**CABINET MEMBER FOR ENVIRONMENT – 19 DECEMBER 2019**  
**LONG WITTENHAM: HIGH STREET – PROPOSED AMENDMENTS**  
**TO TRAFFIC CALMING BUILD OUTS**

**Report by Interim Director for Community Operations**

Drawing title <b>HIGH STREET, LONG WITTENHAM CYCLE BY-PASS IN EXISTING BUILDOUTS</b>					
Drawing Status Scale @ A3    Drawn by    SRF    Checked by    LMD    Approved by    AJP 1:200    Date drawn    19.01.12    Date checked    03.02.12    Date approved    08.02.12					
Oxfordshire Project No. & File Ref S-000579

Drawing No.	S-000579-DET-000-001	Revision	1

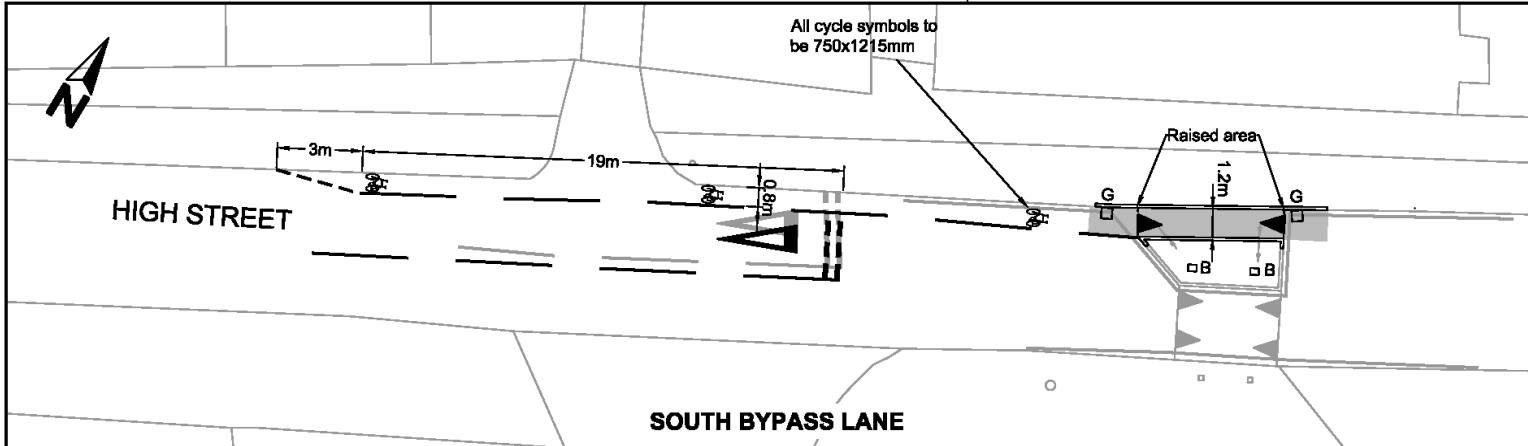
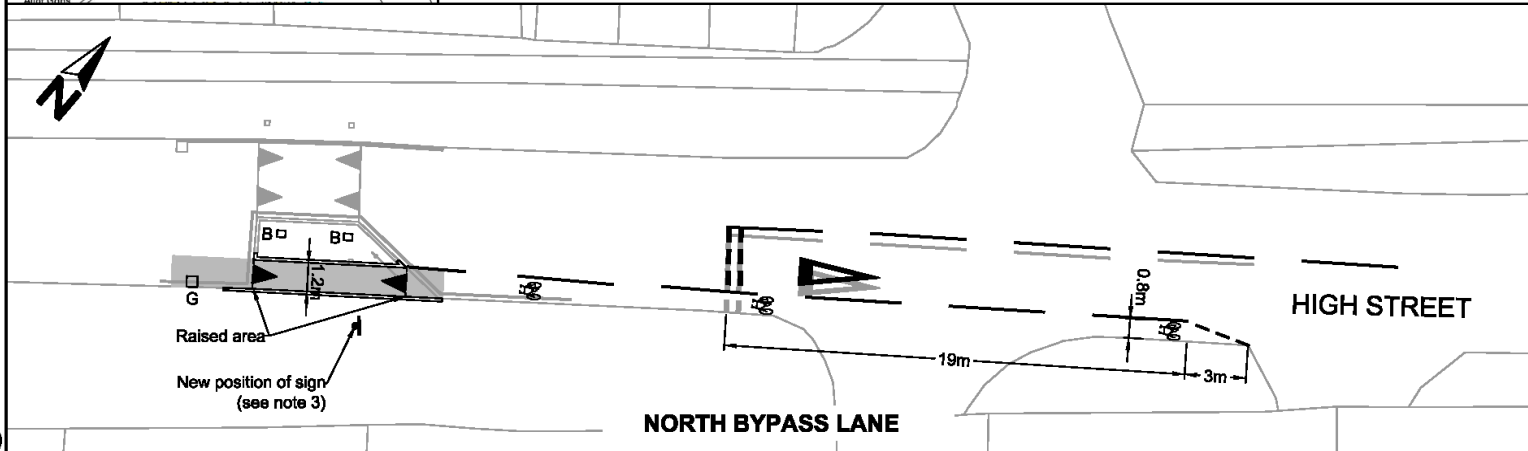
8. Thames Valley Police did not object but did note a concern that without adequate maintenance, such cycle bypasses became unattractive to cyclists due to the accumulation of debris and vegetation, thereby negating the benefit of their provision.

9. In response to the above concerns the design will have a humped bypass lane making it less likely to become cluttered with debris.
10. Long Wittenham Parish Council objected on the grounds that the width of the cycle provision – including both the advisory cycle lanes on the approach and the cycle bypasses – was inadequate and could present a hazard to cyclists, including encouraging cyclists to pass stationary traffic on its nearside and on re-joining the carriageway after passing through the build-out and a more general concern that the proposals were inconsistent with the Neighbourhood Development Plan – adopted jointly by the parish council and South Oxfordshire District Council – which includes a significant environmental enhancement to the village, including addressing traffic congestion at peak periods, taking account also of the planned relocation of the primary school and the provision of an off-carriageway route for pedal cyclists to avoid the High Street.

11. An objection was also received from a resident adjacent to one of the existing build outs stating that the proposals were unnecessary as pedal cyclists currently use adjacent dropped kerbs and the footway to bypass the feature, and noting more generally that parking at school journey times in particular was an effective traffic calming measure in itself, negating the need for any build-outs and also noting that the existing road humps presented a noise and in particular vibration problem for adjacent premises, which – due their being 300 years old - were, due to their foundations being much shallower than current standards, susceptible to damage particularly when larger vehicles travelled over the humps.

14. Expressions of qualified support were received from HARBUG and the Oxfordshire Cycling Network, who though also noted concerns about the narrow width of the cycle provision, in particular the 0.8m width advisory cycle lanes on the approaches to the cycle bypasses and also the need to provide a cycle lane on the exit from the bypasses, together with measures to prevent parking in the immediate vicinity by providing waiting restrictions possibly also supplemented by kerbing to ensure compliance by drivers. Concerns were also expressed that without adequate maintenance the bypasses would be prone to the accumulation of debris etc.

The PC looked at your plans and the description above and found there is an immediate discrepancy in the width described. On the plans the new lanes are marked 0.8m and above you state approx 1.2m?

However the PC has also looked at OCC's own advice on the provision of cycle lanes and has found that these widths are both well below the recommended minimum width as set out in your own guidance documents.

3.2.17 The widths of both mandatory and advisory cycle lanes are the same as for stepped cycle tracks: 1.5m to 2m with **1.8m being the recommended width.**

3.2.18 **Where the minimum width cannot be attained over the majority of its length, cycle lanes should not normally be provided.** Research by Parkin J & Meyers C, 2009 suggests cycle lanes can cause motorists to leave a smaller and in **the case of narrow lanes inadequate space when overtaking a cycle user.**

The PC also looked carefully at your plans as it is not very clear how even the 0.8m substandard cycle lanes could be fitted in?

We note that there are two references to “bypass lanes”. We are extremely concerned about how these might be constructed. It would appear that you intend to widen the road ( which would be essential even with the narrow cycle lanes) and that to do so you will have to close the road whilst work is underway. There would be no safe way of relocating the kerbs without a full road closure which would have an undue impact on the residents getting around the village versus the perceived minor improvements for cyclists. At the south location there is a telegraph pole close behind the kerb and this carries overhead power to the High Street. Relocating this would put put electricity off, a further serious inconvenience for High Street residents.

12. Noting the above concerns it is accepted that although the limited width of the road precludes cycle provision meeting current standards and also that there will be, in practice, times that the cycle lanes may not be passable due to traffic conditions, provision is considered to be an improvement and a relatively low cost measure that in no way jeopardises longer term improvements contained within the Neighbourhood Development Plan.

13. Noting the concerns over the existing road humps, the scheme was constructed in 1995 and research carried out by the Department for Transport on road humps concluded that they presented no realistic risk of structural damage to adjacent properties arising from ground borne vibrations.

15. The above concerns are noted but the limited road width and also the budget available preclude the provision of wider cycle lanes/bypasses or the physical segregation of the cycle lanes. The introduction of waiting restrictions will, however, be explored subject to funding and consultation.
